# Access Compliance Report

## Public Rights-of-Way

| Intersection ID: 22484 | Main Street: RIVER_OAKS_LN | Cross Street: SHARON_VIEW_RD | Location: NW           |
| ADA ID: A906B344D43B   | Ramp Type: PerpDiag        | Initial Pass/Fail: Fail      | Overall Compliance: No |

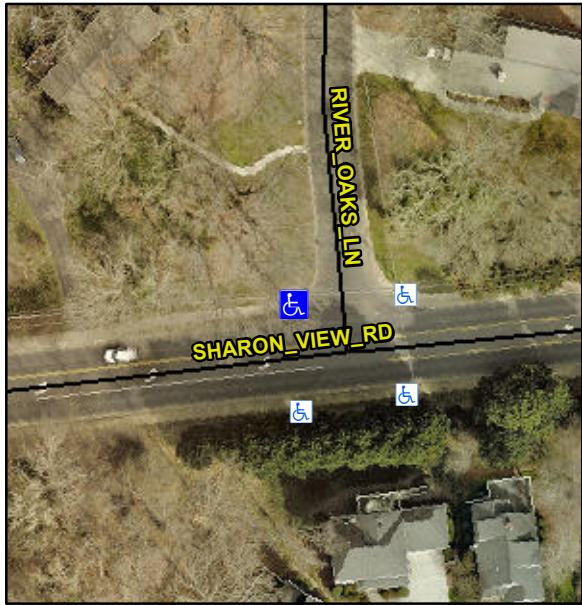
| Codes/Mitigation Info/Possible Solution  |   |                               | Field Measurements/Component Compliance |                       |       |            |                             |      |
|--|---|-------------------------------|---|-----------------------|-------|------------|-----------------------------|------|
|  |   |                               | No                                      | Ramp Width (in)       | 34.0  | No         | Ramp XSlope (%)             | 4.1  |
| PROW/ADA:  |   | Not Found, R304.5.1, R304.5.3 | N/A                                     | Shared Landing?       | N/A   |            |                             |      |

| Codes/Mitigation Info/Possible Solution  |   |                               | Field Measurements/Component Compliance |                       |       |            |                             |      |
|--|---|-------------------------------|---|-----------------------|-------|------------|-----------------------------|------|
|  | <b>Remove &amp; Replace Curb Ramp With Two New Directional Ramps or Equivalent.</b> |                               | N/A                                     | Ramp Length (in)      | 108.0 | Yes        | Ramp Slope (%)              | 5.8  |
